Request for Class II Permissive Change

FCC ID: 2A28USN339D

Subject: FCC Class permission change for FCC ID: 2A28USN339D

This project is a CIIPC submission to our product: Smart Phone, model: SN339D, the device is identical to the previous certified except for the changes as below:

Adjust the ANT3 antenna pattern:

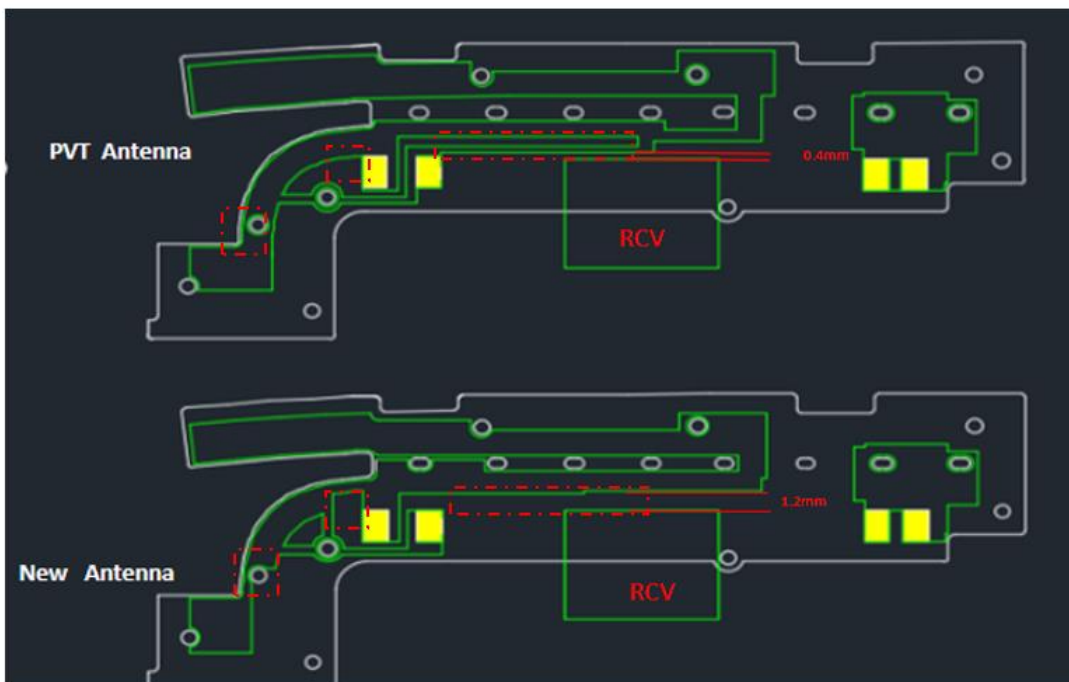
The distance between RCV area and antenna area is changed from 0.4mm to 1.2mm.

This adjustment does not affect the RF performance of the antenna.
